E7515A-06A

Modification Recommended Service Note

E7515A UXM Wireless Test Set

Customer Recovery Image is Deprecated - minimum recommended UXM software version is 1.4.3.0

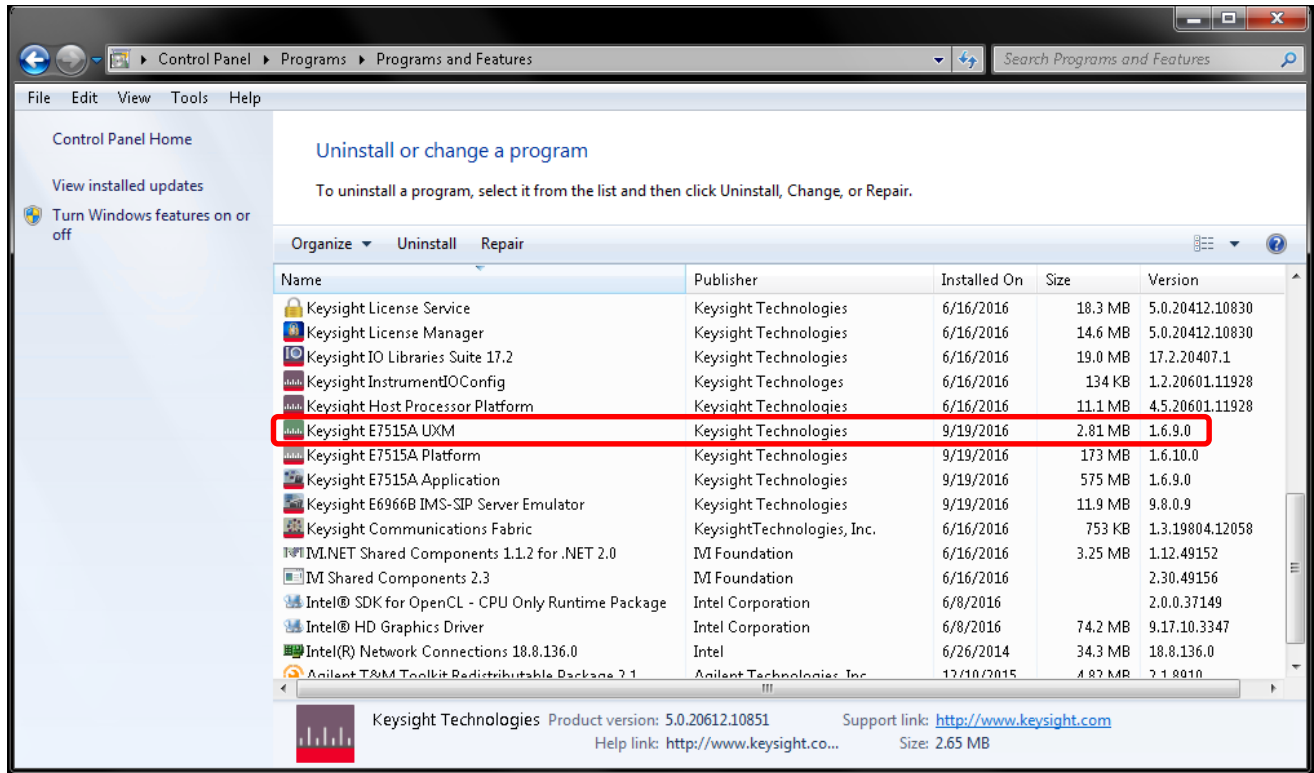
Customers upgrading to 1.7.1.0 will also see a **Customer Recovery Image is Deprecated** warning message if the Windows version is also old and needs updated.

NOTE: This is a warning message and will not affect the UXM performance.

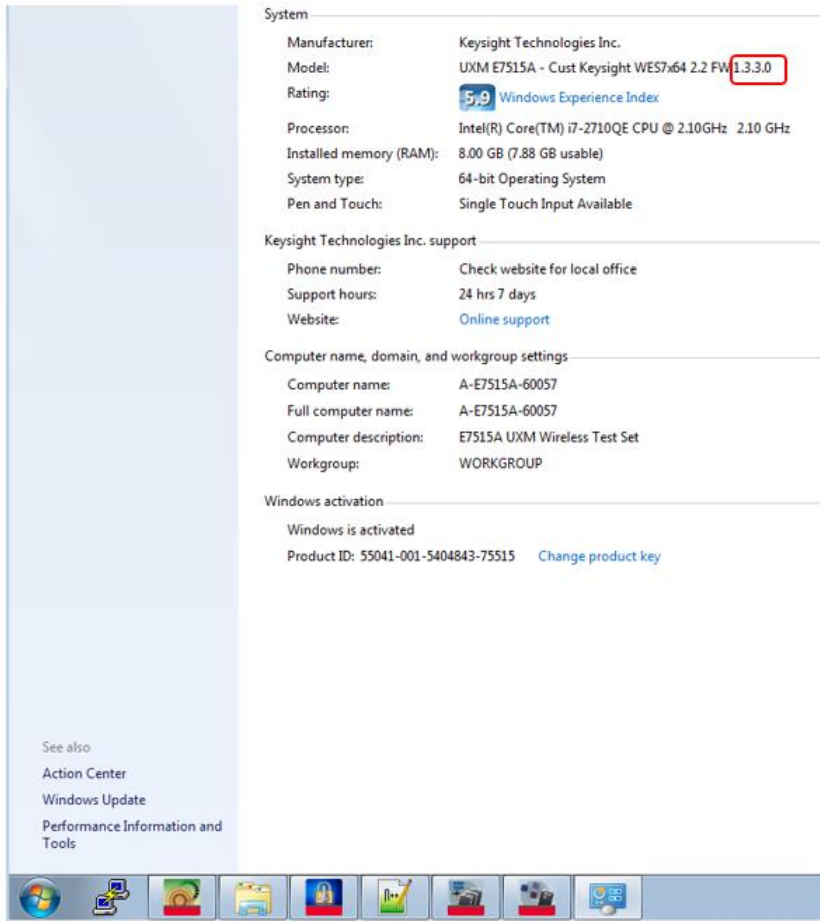
2. Next check the Windows version by going to Windows/Start, then select “Computer”, right click, and select “Properties”.

The Windows version can then be easily checked in the “Properties” windows:

If the revision number shown is below 1.7.x.x (i.e. like the above image), please contact your Keysight Technical Support engineer to check your instrument and upgrade the Windows Recovery image at your next calibration.
